# CITY OF ALBUQUERQUE

**Re: Sawmill Pond Modification-Sawmill Village Wastewater Reuse**

## DRAINAGE AND TRANSPORTATION INFORMATION SHEET

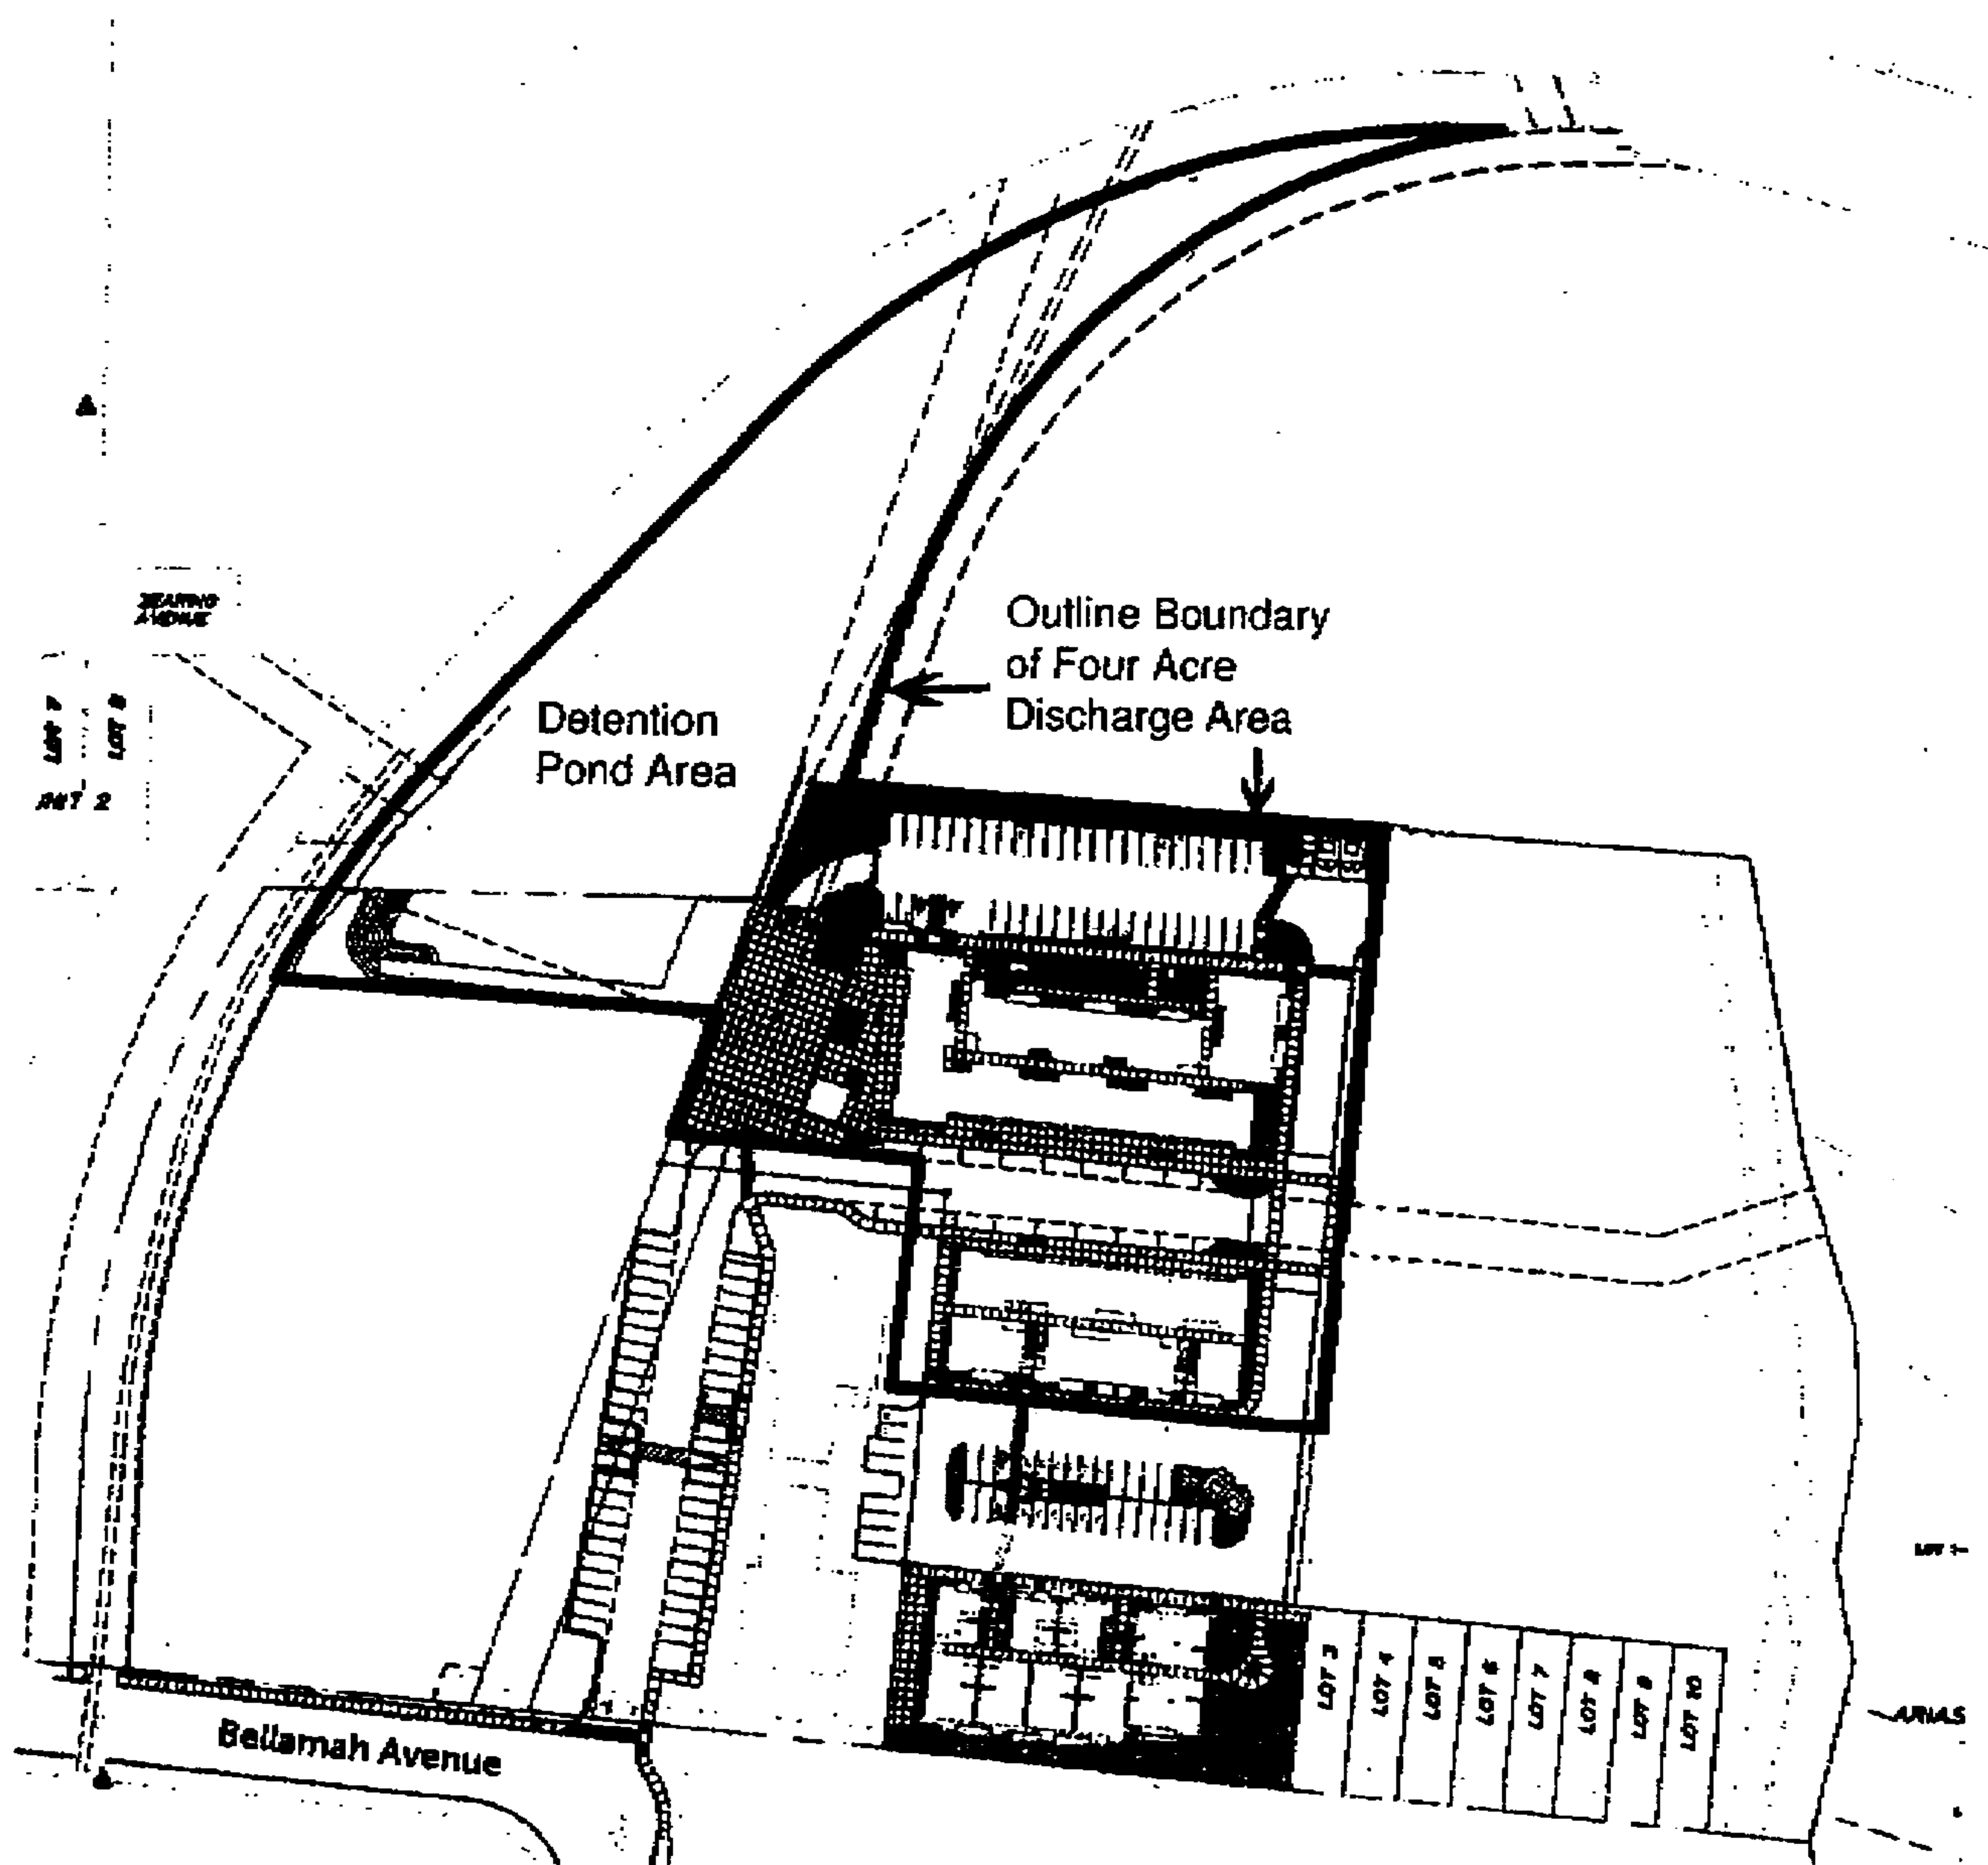
provide as-builts for outlet pipe

get acknowledgment from Sammi  
for an OK up it.

maintain slope of pipe

and water quality specs  
and address in the letter
